Global Nuclear Fuel

February 29, 2008

Subject: Response to NRC Request for Additional Information Dated 12/21/07 for Model No. RAJII Package

GNF Responses to RAIs Documented in NRC Request for Additional Information Dated 12/21/07 (TAC No. L24102)

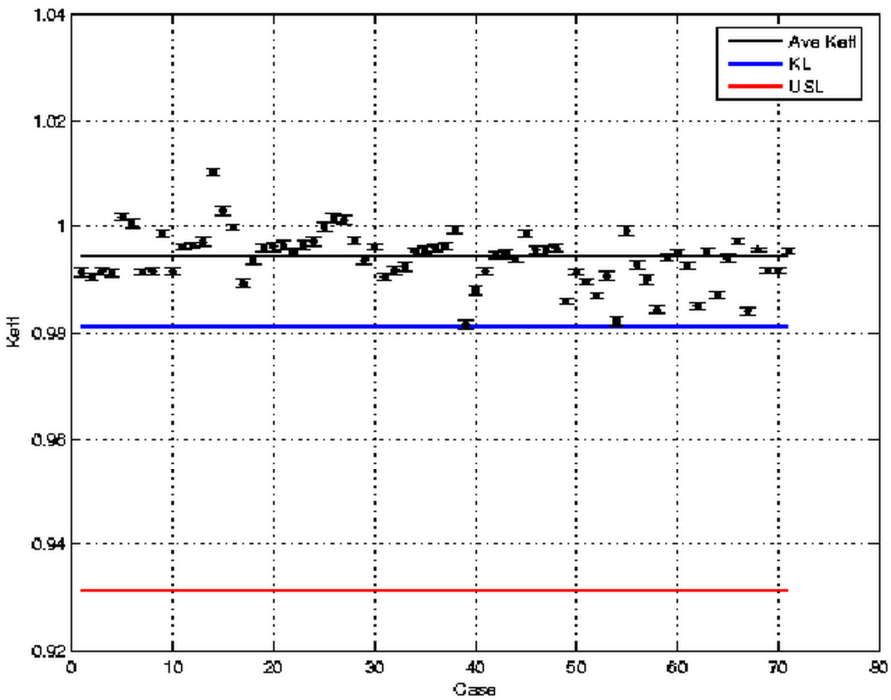
RAI #6-2

Provide a discussion addressing the implications of and the measures taken to address the resulting phenomenon of the GEMER computer code systematically underestimating the eigenvalues in the criticality analysis.

Based on the information submitted it appears that the GEMER computer code systematically underestimates the eigenvalues of all the benchmark experiments.

Comparisons of GEMER (ENDF/B-IV) with MCNP5 (ENDF/B-VII) were made in the GNF responses to the NRC RAIs dated 11-08-07. In this table, the results showed comparisons between the two codes and cross-section data sets for a representative set of eight (8) pin-lattice benchmark experiments. The results showed a systematic under-prediction of the GEMER code of ~0.01 Δk in comparison to MCNP5 and critical experiment. Discussion at the 1/22/08 between GNFA and the NRC provided additional information concerning the implications and measures taken to address this known, systematic under-prediction bias associated with the GEMER code.

The GEMER validation consists of direct comparison between GEMER and 280 critical benchmark experiments. Of these 280, seventy-one (71) are applicable to low-enriched UO2 fuel rods in water with surrounding and intervening structural materials similar to the RAJ-II shipping container. This validation has been provided to the NRC in Reference 6.

The figure below shows the results of the GEMER validation using the 71-benchmark critical experiments for low-enriched UO_2 pin lattice in water critical experiments. As can be seen from

these results, the GEMER code does show an under-prediction of eigenvalues relative to the critical (keff = 1.0) experimental result consistent with historical behavior. However, the determination of the GEMER bias (-0.0055) and bias uncertainty (-0.0132) from Reference 6 results in a very conservatively calculated Upper Safety Limit (USL) for UO_2 fuel rods in water for the GEMER code of:

USL = 1.0 + (bias – bias uncertainty)- MMS

USL = 1.0 + [(-0.0055) -0.0132)] – 0.05 = **0.9313**

It is GNF's position that this very conservative derivation of the GEMER Upper Safety Limit based on comparison to experimental data is adequate to bound its application to the RAJ-II shipping container analysis.

Figure 1 – Results of Void vs. Water in Fuel/Cladding Region

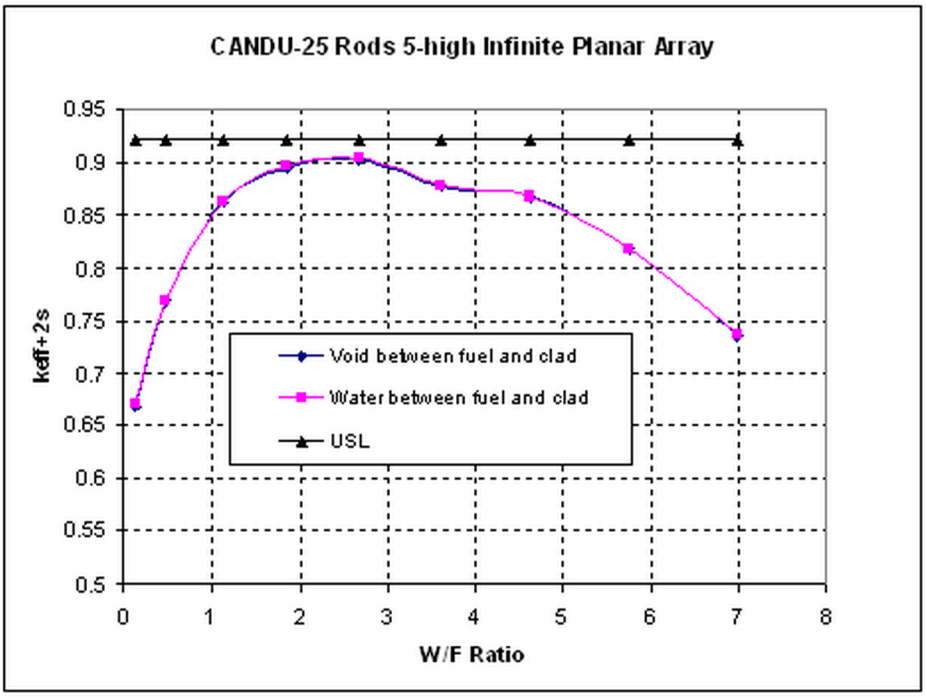
RAI 6-6

Provide a criticality analysis for the shipping container with loose rods case assuming flooded conditions in the pellet/cladding gap volumes.

The non-flooded pellet/cladding gap volumes assumptions do not result in the "most reactive credible configuration."

Reference 13 of the Safety Analysis Report (SAR) which documents the criticality safety analysis of the shipment of loose rods in the RAJ-II shipping container will be updated to include calculations of the loose rod case assuming flooded conditions in the pellet/cladding gap volumes.

The results of these calculations summarizes in Figure 1 below show essentially no reactivity increase for the most limiting case with the final result still being less than the calculated USL of 0.9213 for UC rods:
